Project	IEEE 802.16 Broadband Wireless Access Working Group < http://ieee802.org/16 >	
Title	Figure Change	
Date Submitted	2007-01-11	
Source(s)	Peretz Feder – Alcatel-Lucent Philip Barber - Huawei	pfeder@alcatel-lucent.com , pbarber@huawei.com
Re:		
Abstract	Changes to Figure 500	
Purpose	Adoption	
Notice	This document has been prepared to assist IEEE 802.16. It is offered as a basis for discussion and is not binding on the contributing individual(s) or organization(s). The material in this document is subject to change in form and content after further study. The contributor(s) reserve(s) the right to add, amend or withdraw material contained herein.	
Release	The contributor grants a free, irrevocable license to the IEEE to incorporate material contained in this contribution, and any modifications thereof, in the creation of an IEEE Standards publication; to copyright in the IEEE's name any IEEE Standards publication even though it may include portions of this contribution; and at the IEEE's sole discretion to permit others to reproduce in whole or in part the resulting IEEE Standards publication. The contributor also acknowledges and accepts that this contribution may be made pu

Figure 500 - Network Attachment

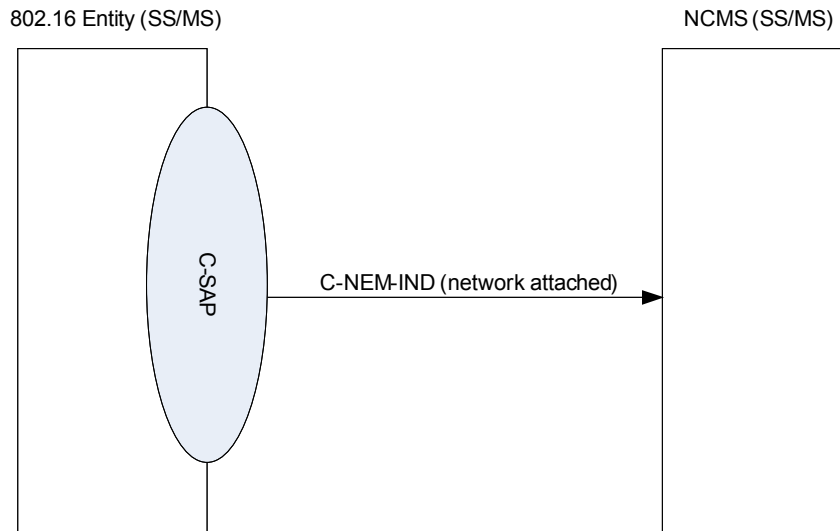
8 Figure 500 provides 3 scenarios:

- 10 1. M_MTM-Req/Rsp (power on), which is already covered in Figure 502
- 11 2. C-NEM-Req/Rsp (ranging), which is already covered in Figure 498
- 12 3. C-NEM-IND (network attached)

15 The modified Figure below removes the first 2 scenarios and only depicts the

16 network attached case.
